# MEMO

Date:  
July 13, 2017

Subject:  
DRAFT - Admin Bldg No. 1 Investigation Report Response to Comments  
RACER Trust, Buick City, Flint, Michigan

**FIGURE 1. DELINEATION LOCATIONS**

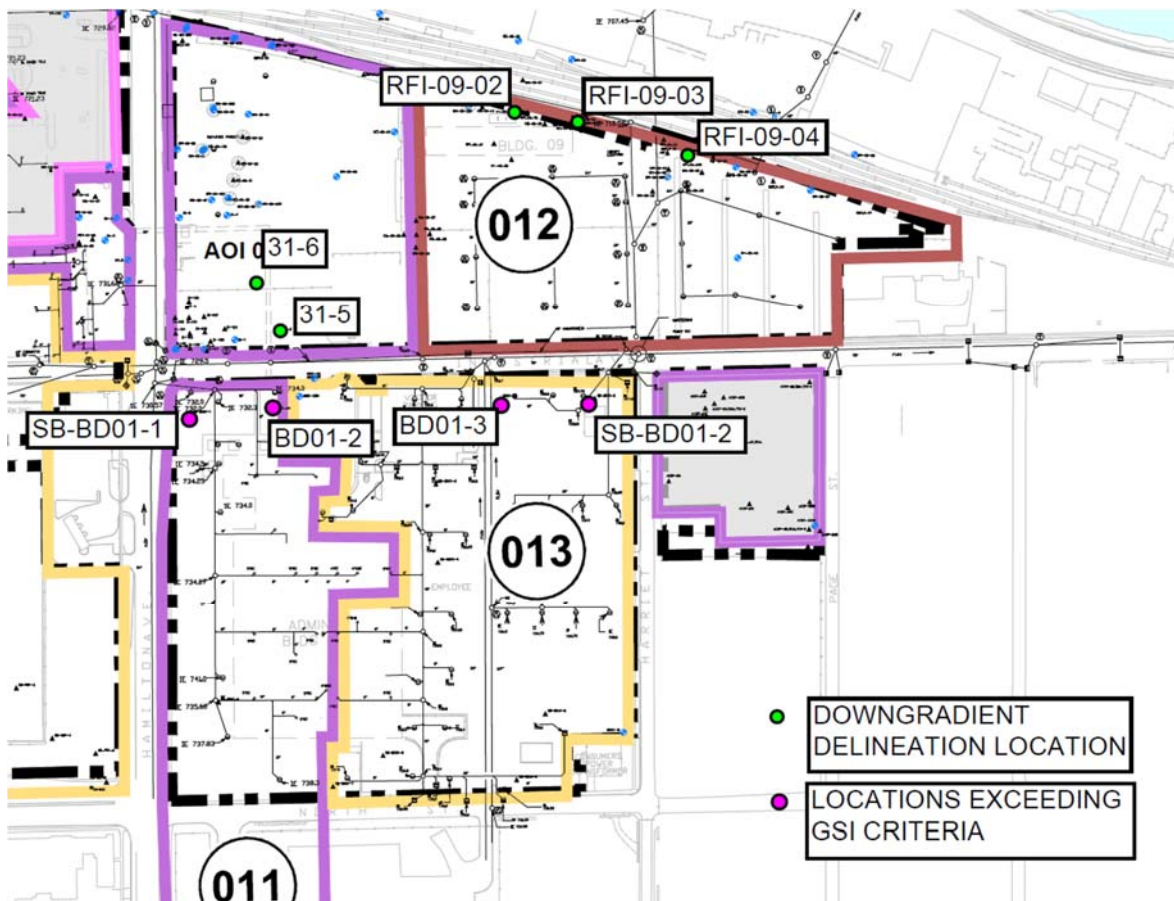
**Comment:** Please indicate which down gradient samples you are referring to and the degree of change between the "upgradient" and "downgradient" locations.

**Response:** **Table 1** below summarizes the location and concentrations of the exceedances and the delineation samples. The delineation sample for manganese is three orders of magnitude less than the exceedance, while the remaining delineation samples are non-detect for the constituent

of concern (COC). The locations of the exceedances and delineation samples are also shown on **Figure 1**, below.

Please note that the samples collected during the historic use investigation as well as one of the historic samples were collected as grab samples from soil borings. Grab samples contain greater amounts of sediment than samples collected from monitoring wells which leads to increased metal concentrations. Therefore, both unfiltered and filtered groundwater samples were submitted for metals analysis.
